**CITY OF NAPOLEON
BUILDING CONSTRUCTION PERMIT
(1, 2 or 3 Family Dwelling)**

DATE	April 1, 75			JOB NO.	Permit No. 210-75P		
PROJECT	Remodel - 14'-13' Add'n.						
LOCATION	114 Brownell St.						
CONTRACTOR				OWNER			
WEATHER			TEMP.	° at			AM
				° at			PM
PRESENT AT SITE	CITY OF NAPOLEON ENGINEERING DEPT. PLAN APPROVAL BY: <u>[Signature]</u> DATE: <u>4/1/75</u>

TO
 Gregory Rudolph
 114 Brownell St
 Napoleon, Ohio
 Addendum To Plan Approval

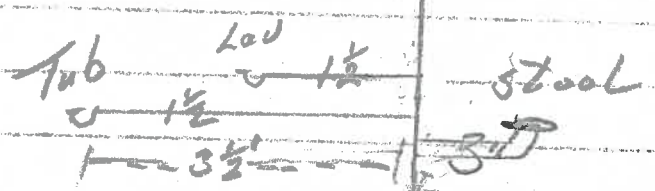
- > During plan review and requires compliance with the City's 1, 2 and 3 Family adopted plumbing codes:
 - 1) Provide clean out for the building drain whenever ^{change of} direction is greater than 45°. ^{Sec. BB-51-21 of O.B.C.}
 - 2) No vent terminal ^{is} a drainage system shall be ^{on} directly beneath ^{any} window ^{and/or} within 10 ft. horizontally ^{of} such an opening. ^{Sec. BB-51-60 of O.B.C.}
 - 3) IF No windows are provided for in new bath ^{or} then required to provide mechanical ^{vent} ^{exhaust} system directly to the outside air. ^{Sec. 507.3 of B.O.C.A. Basic Building Code.}
 - 4) Bearing partitions shall have a double top plate. ^{Sec. R-402 of B.O.C.A. Building Code}
 - 5) Provide hand railing to basement. ^{Sec. R-215 of B.O.C.A. Building Code}

Remove overhead ^{light} in area between Laundry Rm & Kitchen.
 protect wiring coming in ⁱⁿ contact with ^{Letter No. 210-75P}
 hot water pipes. ^{plus}
